## Changes to proposed District Map Amendment G-956

A revised version of DMA G-956, dated April 18, 2014, has been posted on the Planning Department website for review. It contains all of the proposed and approved changes that have occurred since March 7, 2014. The following document illustrates all of the changes to DMA G-956.

Changes made to DMA G-956 are organized into two sections, each section describing a different type of revision.

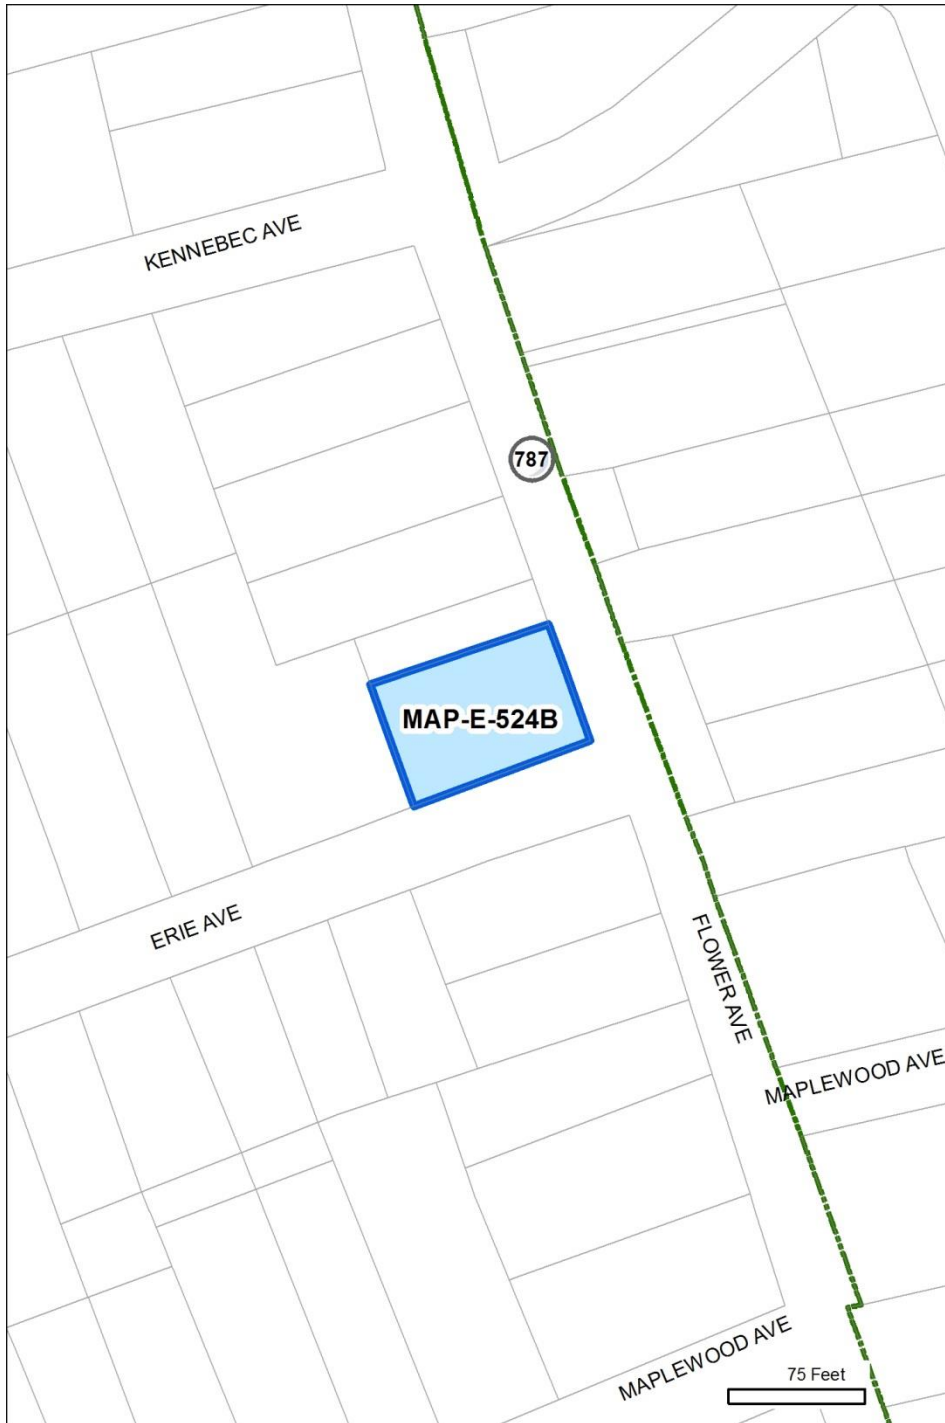
Unique ID: MAP-E-524A		staff error
Master Plan ID: TAKOM-17		
Master Plan:	Takoma Park	
Location:		
Existing Zone:	C-1	
Proposed Conv: (3/7)	CRT-0.5 C-0.5 R-0.25 H-35	
Prop. Revised Conv:	CRT-0.5 C-0.5 R-0.25 H-50	
Category:	Error	
Modifications	Zone Group:	No change
	Overall FAR:	No change
	Comm'l FAR:	No change
	Resid'l FAR:	No change
	Height:	Increased to 50'
<b>Reason for change:</b>		
<p><i>This property is in the Takoma Park/East Silver Spring Commercial Revitalization Overlay, however it was inadvertently left out of the Overlay in earlier versions of the DMA.</i></p> <p><i>The Overlay allows heights to go to 50' with Planning Board approval, and the language of the Overlay will remain in effect under the proposed ordinance.</i></p> <p><i>These properties were remapped to be consistent with the other properties within the Takoma Park/East Silver Spring Overlay.</i></p>

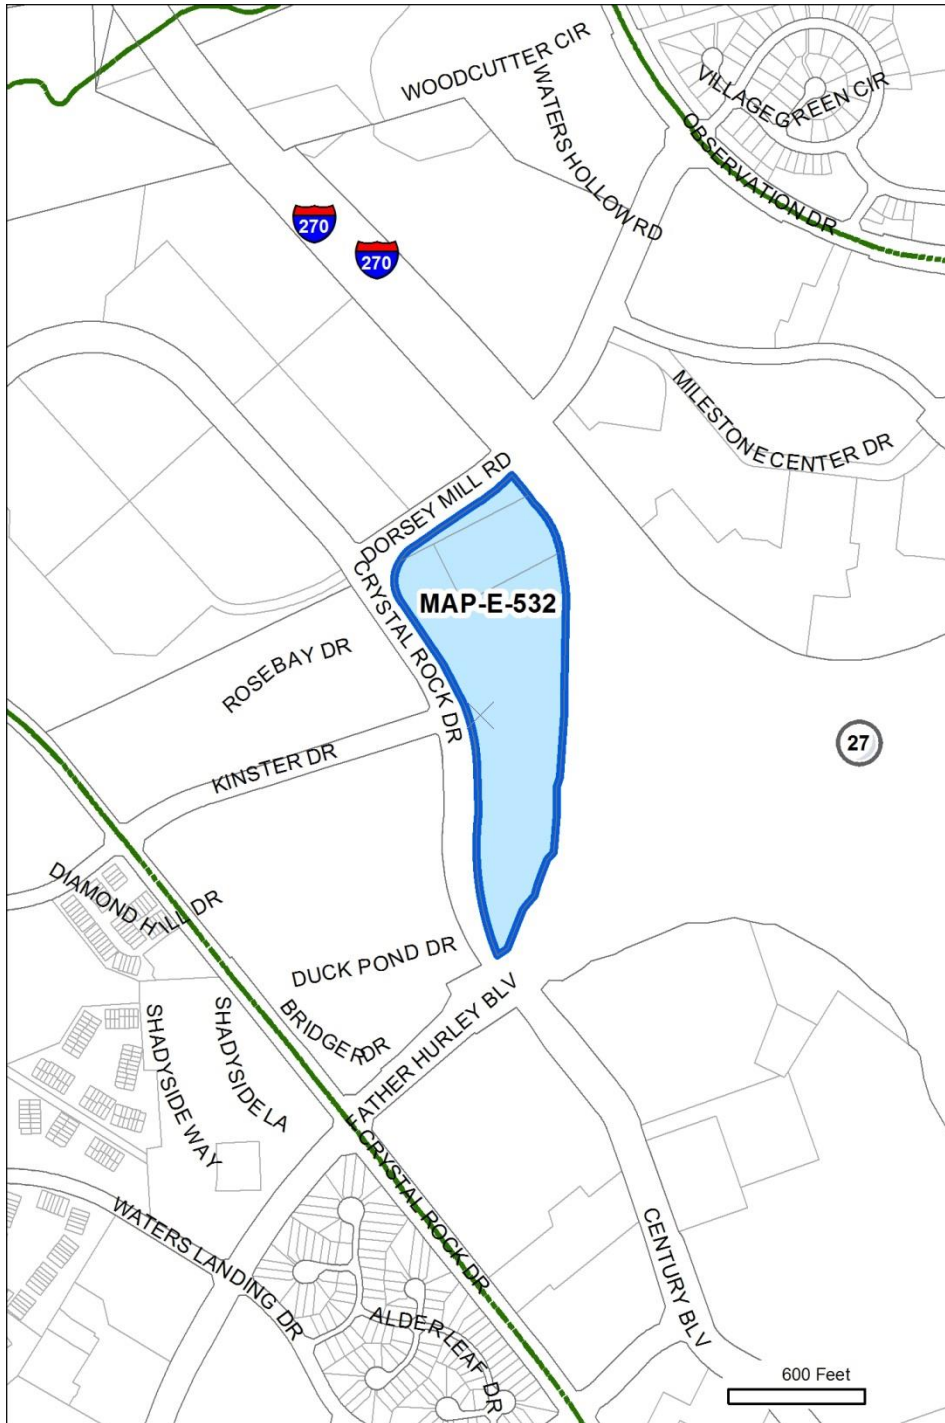
Unique ID: MAP-E-531		staff error
Master Plan ID: GRMTC-08		
Master Plan:	Germantown Town Center	
Location:		
Existing Zone:	TMX-2	
Proposed Conv: (3/7)	CR-2.0 C-1.5 R-1.5 H-180 T	
Prop. Revised Conv:	CR-2.0 C-0.5 R-1.5 H-180 T	
Category:	Error	
Modifications	Zone Group:	No change
	Overall FAR:	No change
	Comm'l FAR:	Reduced to 0.5
	Resid'l FAR:	No change
	Height:	No change
<b>Reason for change:</b>		
<p><i>The Germantown Town Center Plan calls for this property to have a minimum of 70% residential. As a result, Commercial FAR should be limited to 0.5.</i></p> <p><i>Earlier versions of the DMA converted the commercial FAR to 1.5 on this site.</i></p>

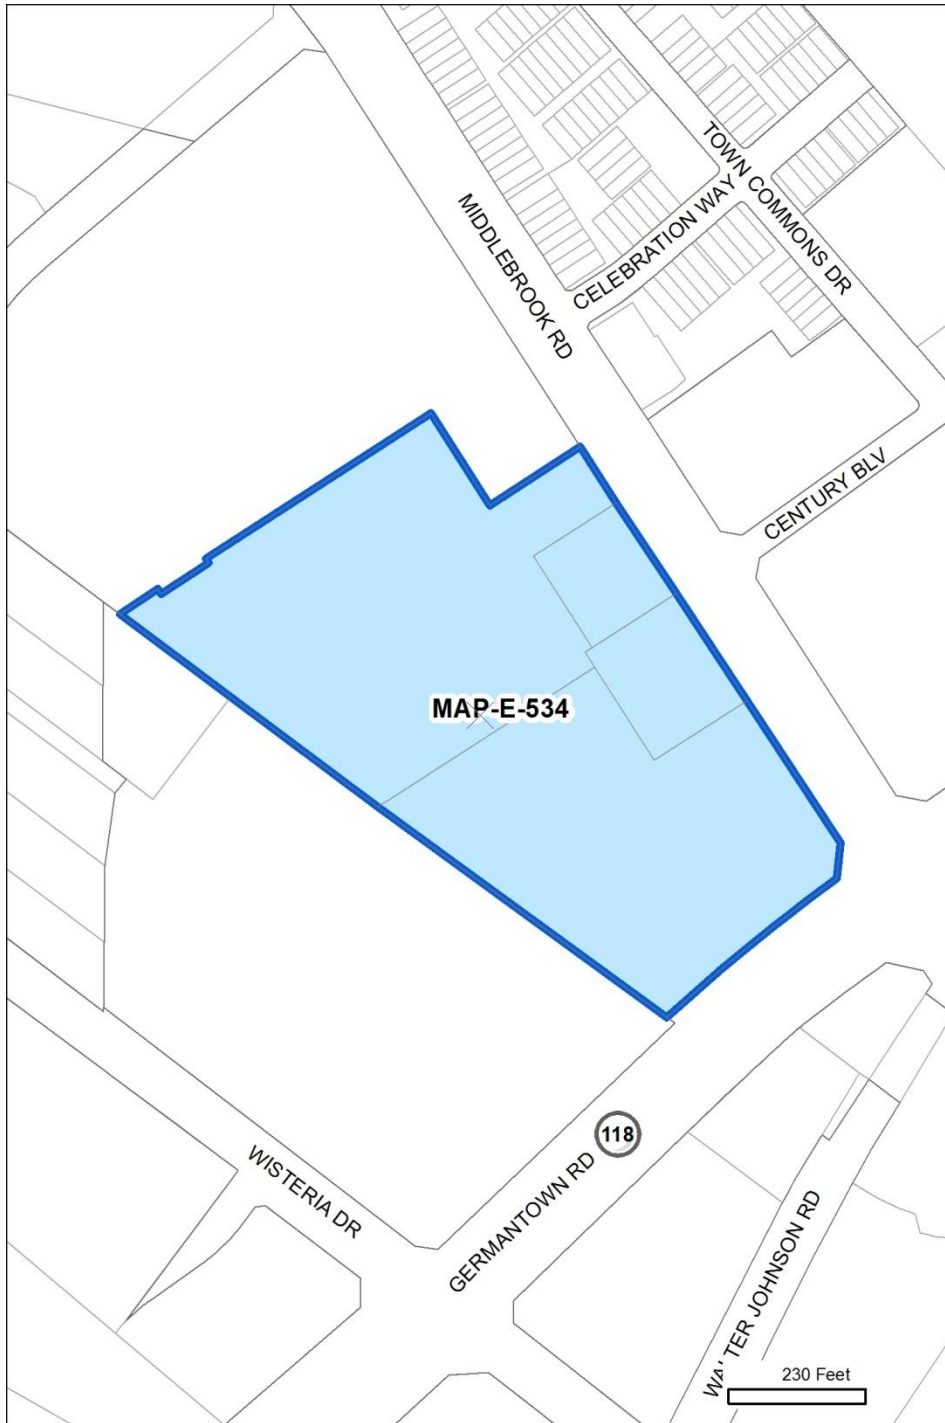
Unique ID: MAP-E-533		staff error
Master Plan ID: GRMTC-09		
Master Plan:	Germantown Town Center	
Location:		
Existing Zone:	TMX-2	
Proposed Conv: (3/7)	CR-1.5 C-1.0 R-1.0 H-145 T	
Prop. Revised Conv:	CR-1.5 C-1.0 R-1.0 H-100 T	
Category:	Error	
Modifications	Zone Group:	No change
	Overall FAR:	No change
	Comm'l FAR:	No change
	Resid'l FAR:	No change
	Height:	Reduced to 100'
<b>Reason for change:</b>		
<p><i>The Germantown Town Center Plan indicates that this property should have a height limit of 100'.</i></p> <p><i>Staff erroneously translated this area to a height of 145', which applies to properties to the east only.</i></p>

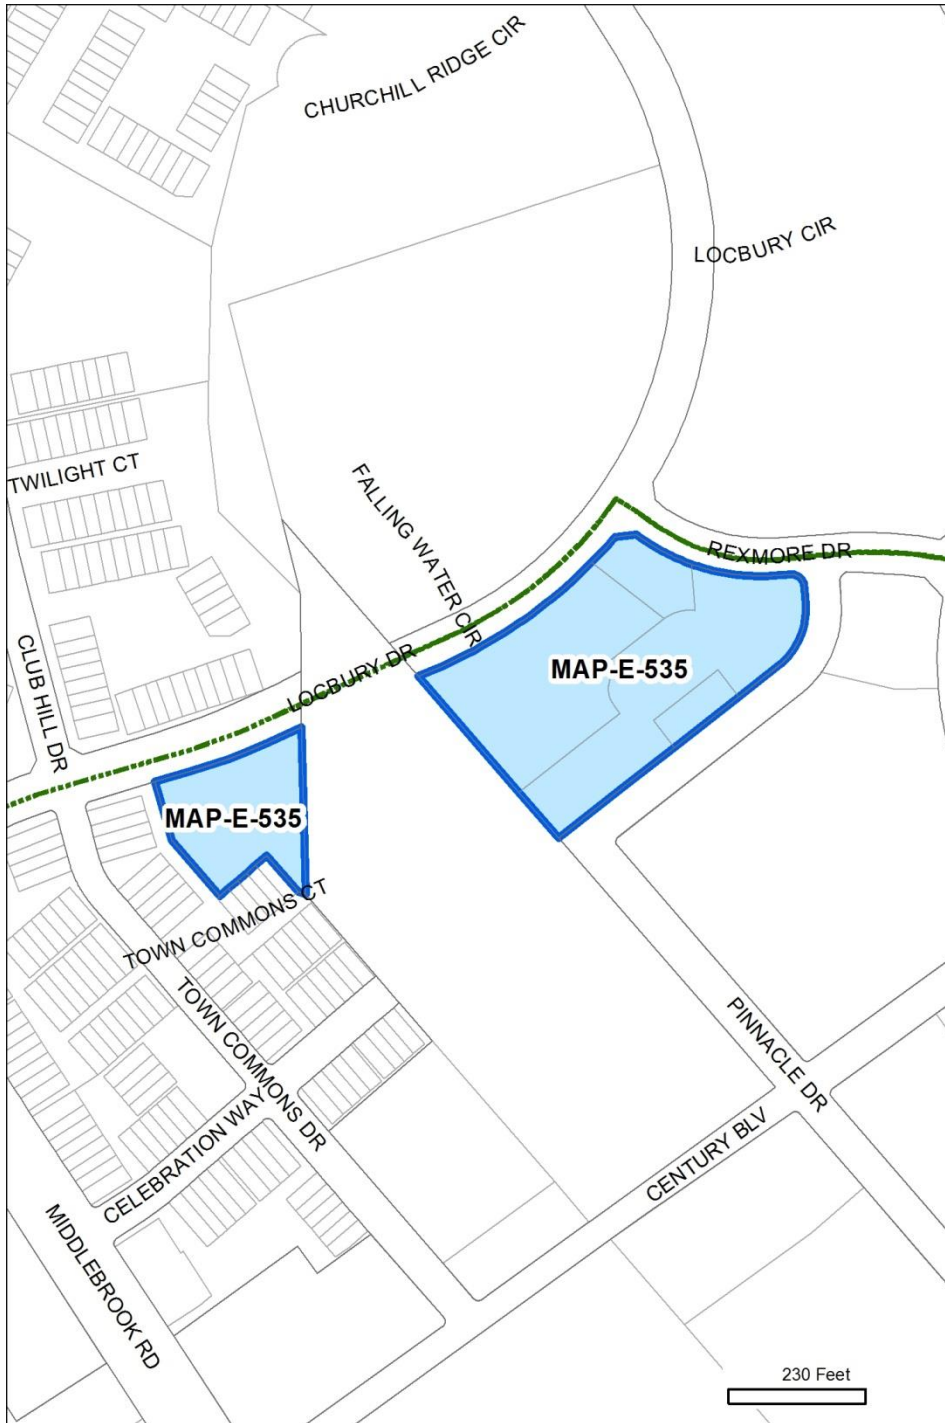
Unique ID: MAP-E-534		staff error
Master Plan ID: GRMTC-10B		
Master Plan:	Germantown Town Center	
Location:		
Existing Zone:	TMX-2	
Proposed Conv: (3/7)	CR-1.0 C-0.75 R-0.75 H-100 T	
Prop. Revised Conv:	CR-1.0 C-0.75 R-0.5 H-100 T	
Category:	Error	
Modifications	Zone Group:	No change
	Overall FAR:	No change
	Comm'l FAR:	No change
	Resid'l FAR:	Decreased to 0.5
	Height:	No change
<b>Reason for change:</b>		
<p><i>The Germantown Town Center Plan indicates that this property should have a maximum of 40% residential uses. As a result, the FAR for residential should be reduced to 0.5.</i></p>

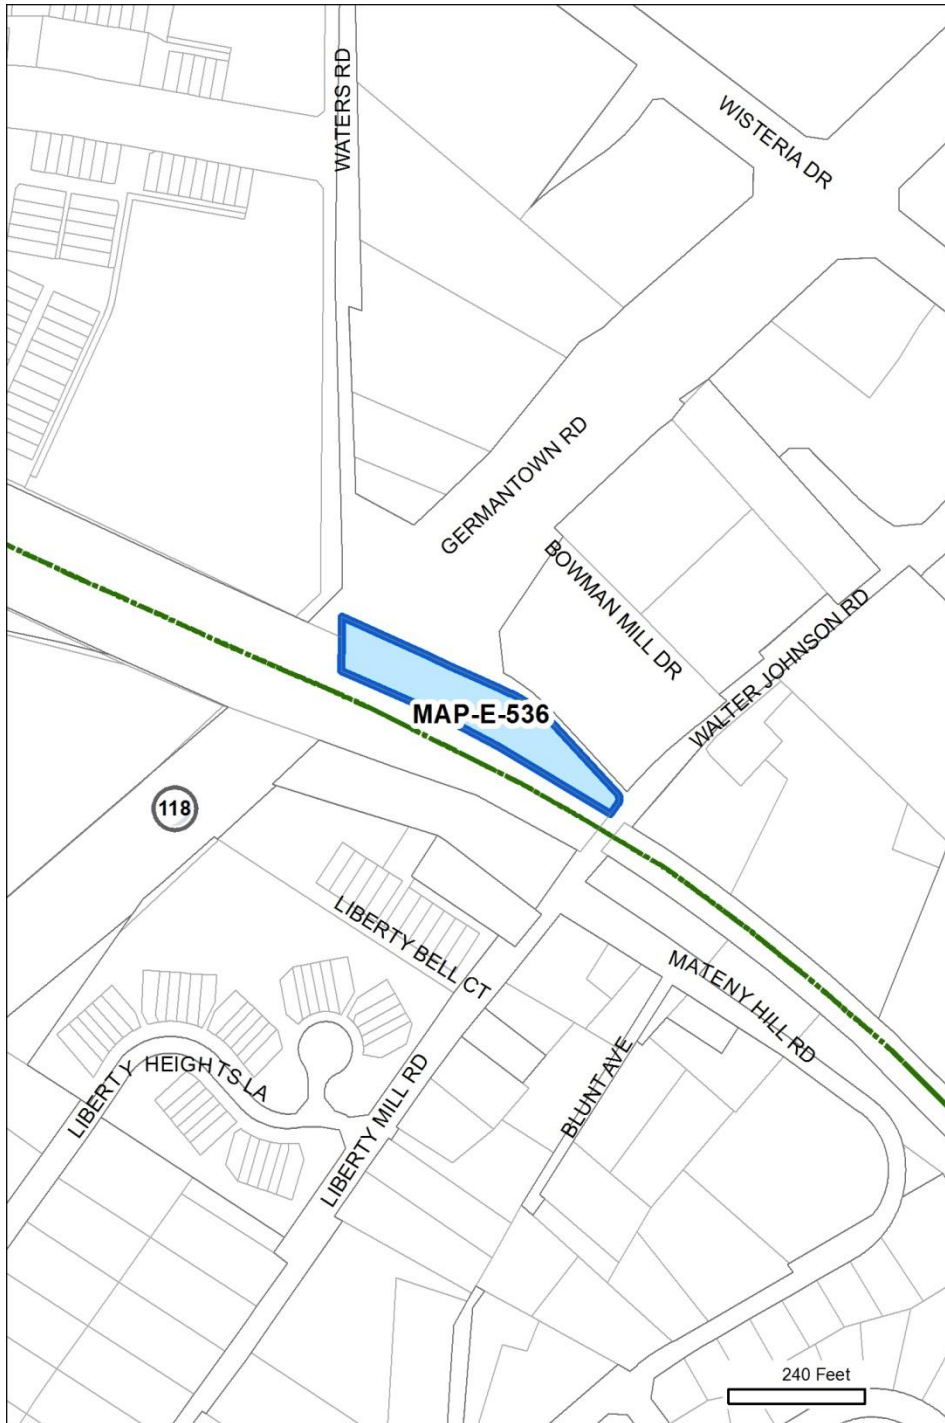
Unique ID: MAP-E-535		staff error
Master Plan ID: GRMTC-11B		
Master Plan:	Germantown Town Center	
Location:		
Existing Zone:	TMX-2	
Proposed Conv: (3/7)	CR-0.5 C-0.5 R-0.25 H-60 T	
Prop. Revised Conv:	CR-0.5 C-0.5 R-0.5 H-60 T	
Category:	Error	
Modifications	Zone Group:	No change
	Overall FAR:	No change
	Comm'l FAR:	No change
	Resid'l FAR:	Increased to 0.5
	Height:	No change
<b>Reason for change:</b>		
<p><i>The Germantown Town Center Plan indicates that this property should have an FAR limit of 0.5. However, a recommendation to limit residential FAR that applies to the neighboring property was inadvertently applied to this property.</i></p> <p><i>Staff believes this property should be given a residential FAR of 0.5.</i></p>

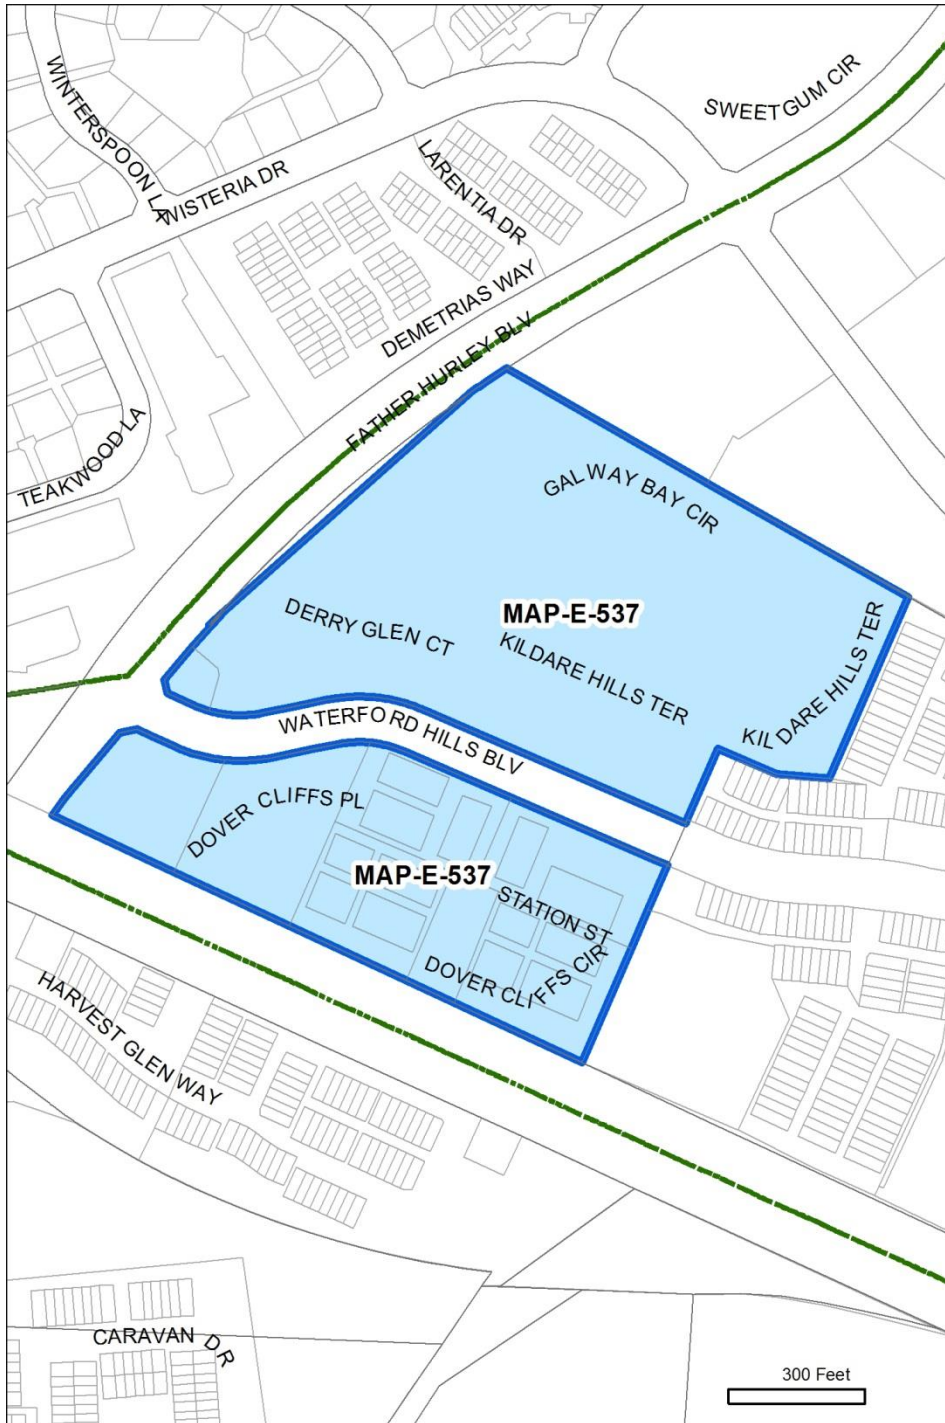
<b>Unique ID:</b> MAP-E-536		staff error
<b>Master Plan ID:</b> GRMTC-20B (add to)		
<b>Master Plan:</b>		Germantown Town Center
<b>Location:</b>		
<b>Existing Zone:</b>		TMX-2
<b>Proposed Conv:</b> (3/7)		CR-2.0 C-1.5 R-1.5 H-150 T
<b>Prop. Revised Conv:</b>		CR-0.5 C-0.25 R-0.25 H-40 T
<b>Category:</b>		Error
<b>Modifications</b>	<b>Zone Group:</b>	No change
	<b>Overall FAR:</b>	Reduced to 0.5
	<b>Comm'l FAR:</b>	Reduced to 0.25
	<b>Resid'l FAR:</b>	Reduced to 0.25
	<b>Height:</b>	Reduced to 40'
<b>Reason for change:</b>		
<p><i>The Germantown Town Center Plan includes a map describing properties. This property was not included in the map, and was given a standard conversion for the TMX-2 zone.</i></p> <p><i>However, upon further review, it became clear that the text does refer to this property and that it should be included with the conversion given to the property referred to in the DMA as non-standard conversion GRMTC-20B.</i></p>

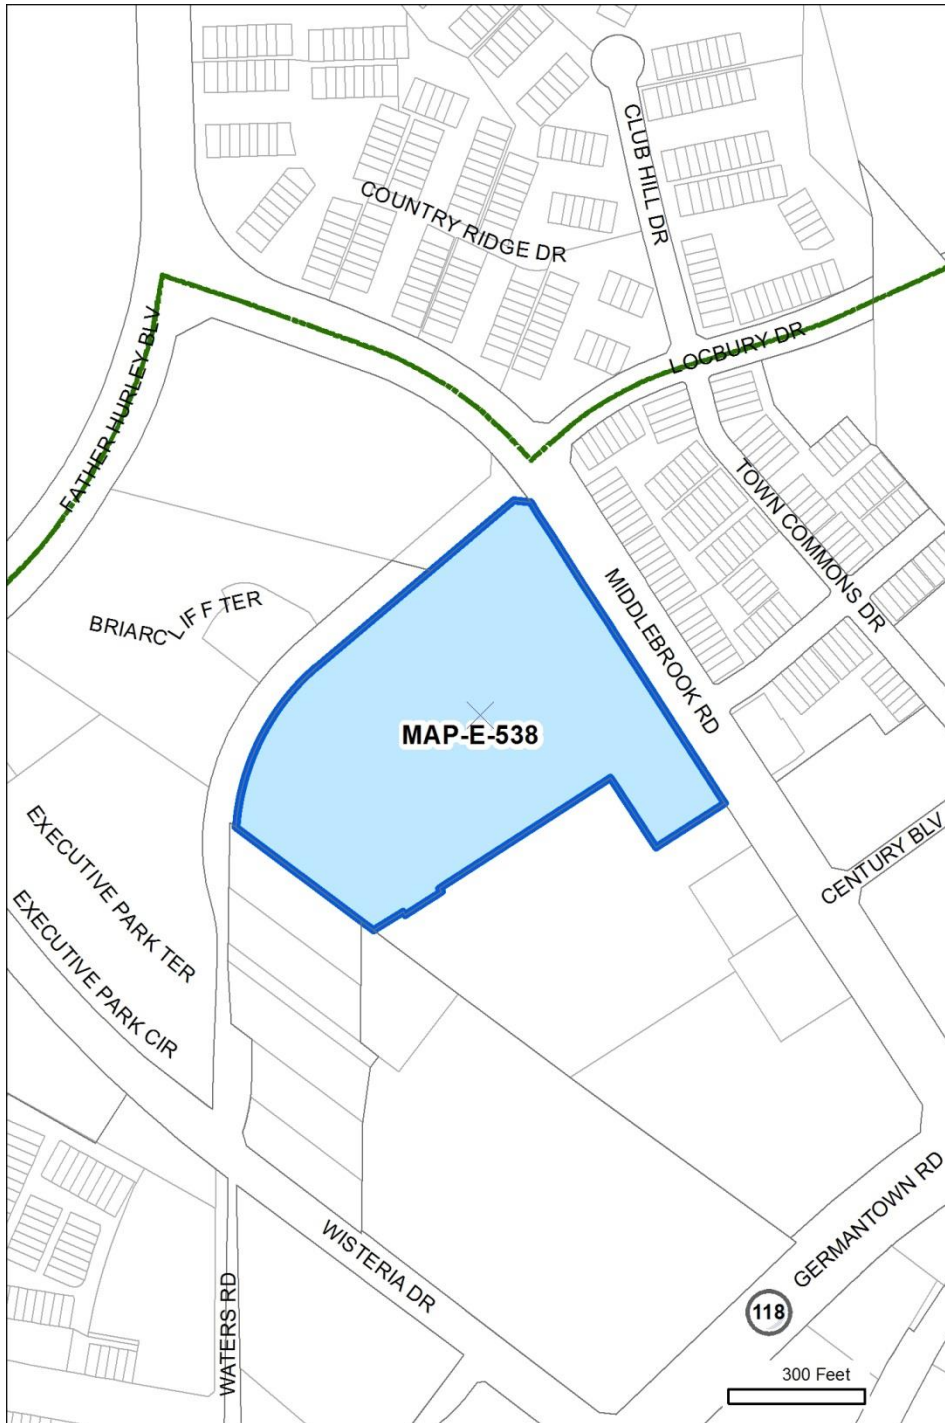
Unique ID: MAP-E-537		staff error
Master Plan ID:		
Master Plan:	Germantown Town Center	
Location:		
Existing Zone:	RMX-2	
Proposed Conv: (3/7)	CRT-1.0 C-0.25 R-0.75 H-65 T	
Prop. Revised Conv:	CRT-2.0 C-0.5 R-1.5 H-65 T	
Category:	Error	
Modifications	Zone Group:	No change
	Overall FAR:	Increased to 2.0
	Comm'l FAR:	Increased to 0.5
	Resid'l FAR:	Increased to 0.5
	Height:	No change
Reason for change:		
<p><i>This property is zoned RMX-2, and the Germantown Town Center Sector Plan only reconfirms the zoning on the site.</i></p> <p><i>Staff inadvertently captured the recommendations for the property next door when crafting the conversion for this property.</i></p> <p><i>It should receive the standard conversion.</i></p>
